Tameside MBC

Cycle Audit - Guide Lane/Denton Road Advanced Stop Lines

Final Report

November 2008

Figure 2 – Guide Lane/Denton Road – existing layout.

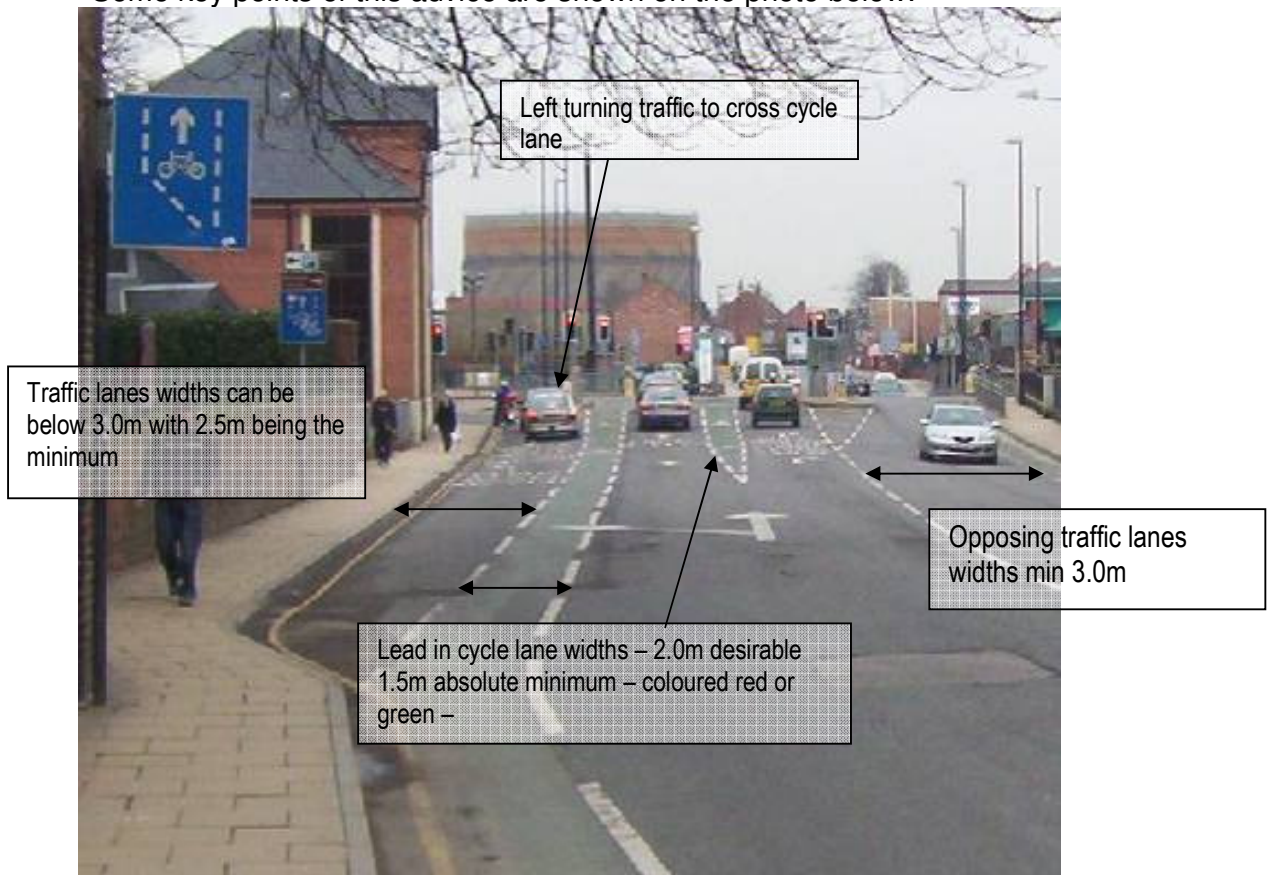
- 3.1 **Site Description:** The Guide Lane/Denton Road junction is signalled controlled with 3 traffic lane approaches on the A6017 with 2 partial width Advanced stop lines. Under current Traffic signs regulations partial width Advanced stop lines require special authorisation from the Department of Transport. The right turn lane has its own signal stage and the advanced stop line is feed by a lead in cycle lane. The straight on and left turn movements run together and the advanced stop line is feed by a “gate” tapered road marking.

- 3.2 On the B6169 there are 2 traffic lane approaches with full width Advanced stop lines feed by a “gate” tapered marking on Stamford Road and Shepley Road. The layout is shown at the back of this report in **Figure 2**.

- The junction looks like it has been widened to provide more traffic lanes as the approach roads are single lane. This will have increased the potential for conflict with cyclists especially for the right turn movement requiring 2 lanes of traffic to be crossed. This manoeuvre would only be suitable for an experienced cyclist who had been trained at Bikeability Level 3. Less experienced cyclists would be encouraged to stop at the pedestrian crossings and use them to cross the road though this would not be convenient.

- Installing an advanced stop line across all three traffic stop lines on the A6017 however could be confusing in that cyclists may stay in the nearside lane and then use the Advanced stop line box to cross into the right hand lane. The present partial advanced stop lines do make it clear which lane to use but the cycle lanes could be extended further back to make it clearer.

- extending the existing lead in right turn cycle lanes back into the hatched area and
- replacing the nearside lane “gate” entries with a new nearside lead in cycle lane from the existing cycle lanes on the A6017 should be considered.

Figure 1 - Drawing Title – Guide Lane/Denton Road – Advanced stop lines proposals with reduced traffic lane approaches Not to scale
Date 14 November 2008 Number 1012 V1

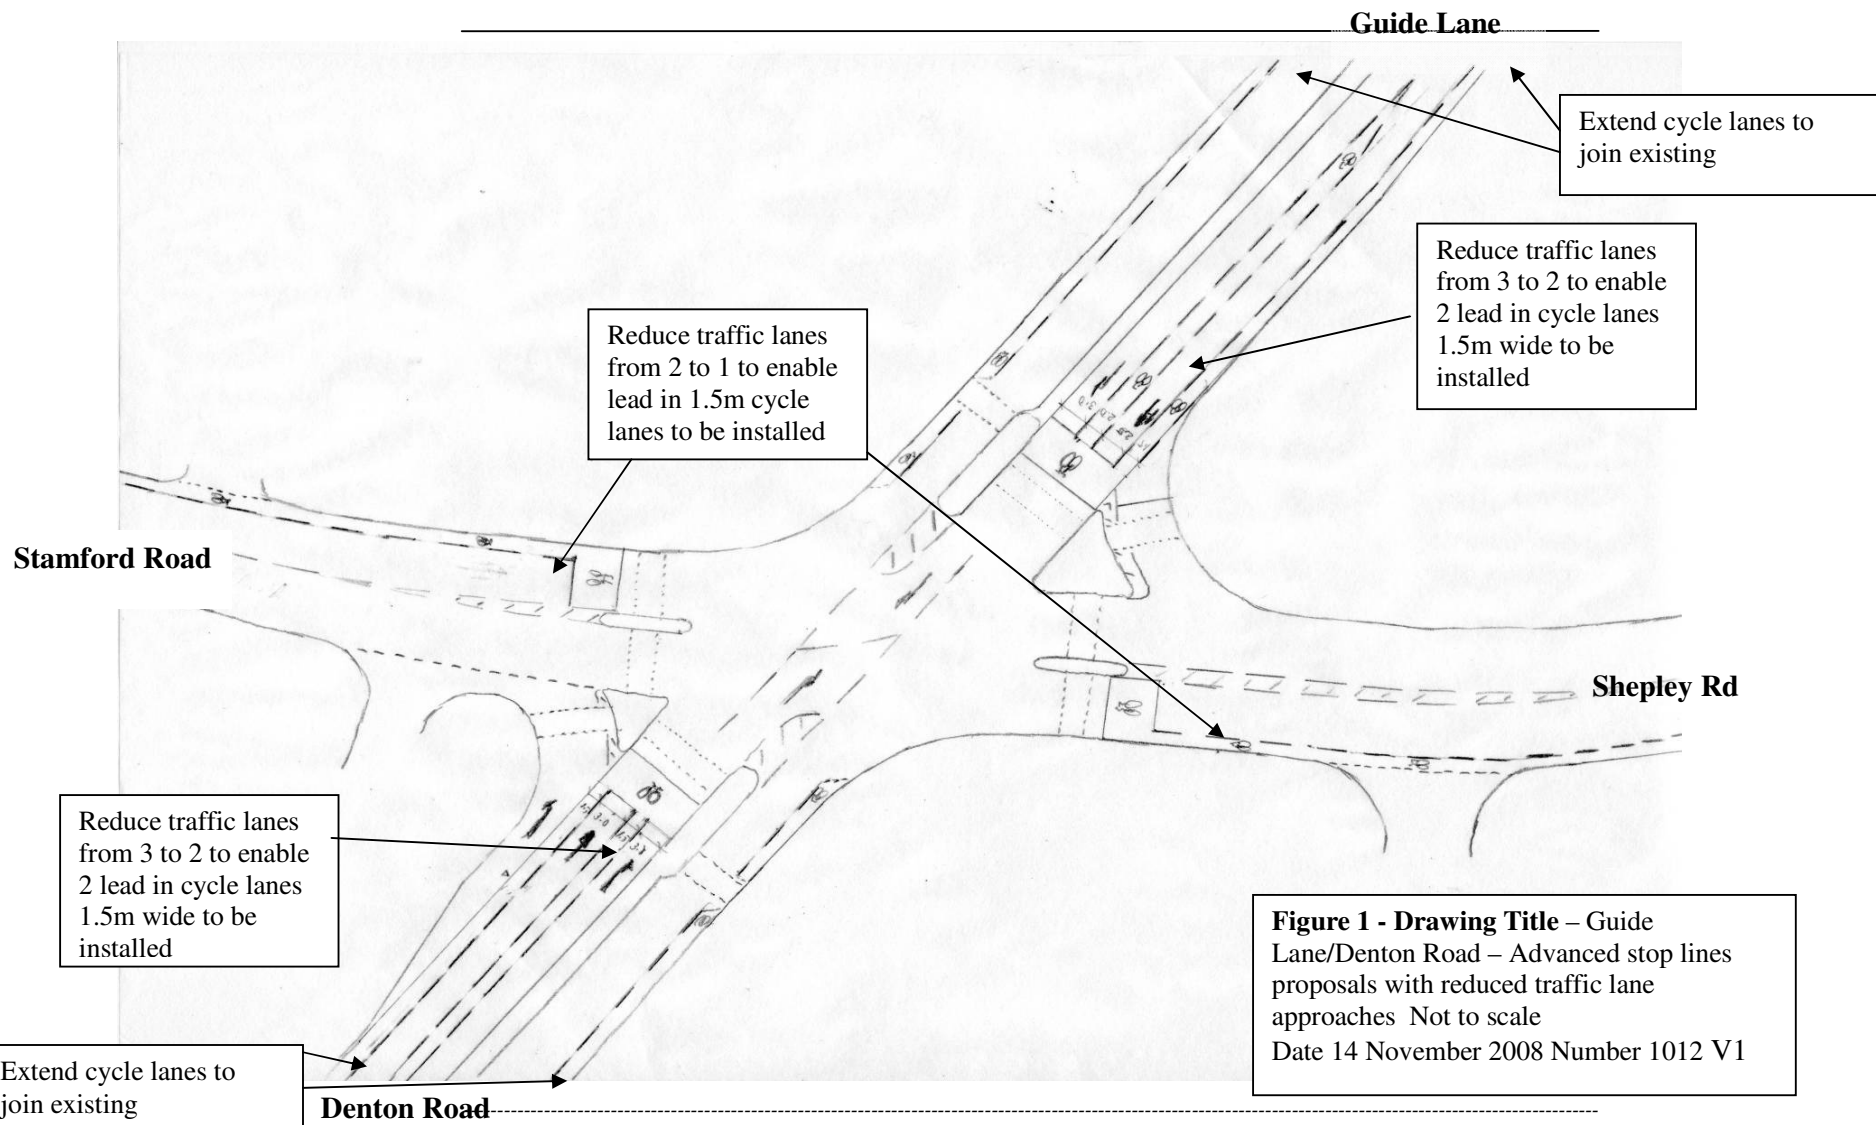
a) *Traffic Lane Reduction* – reducing the number of approach traffic lanes from 3 to 2 on the A6017 at the junction would enable longer and wider lead cycle lanes to be installed feeding full width Advanced stop lines. This would enable cyclists to get past queuing traffic and would be easier to use than the present arrangement. This could be unpopular with motorists as it is likely to increase delays and queuing at the junction. It would require traffic signal modelling to see the effects of this change on the capacity of the junction. A sketch of this proposal is shown in **Figure 1** at the end of this report.

The road scales approximately 9.0m at the stop lines which is wide enough to get 2 cycle lanes at 1.5m wide and 2 traffic lanes at 3m wide. Ideally the cycle lanes should be a bit wider and the traffic lanes reduced accordingly.
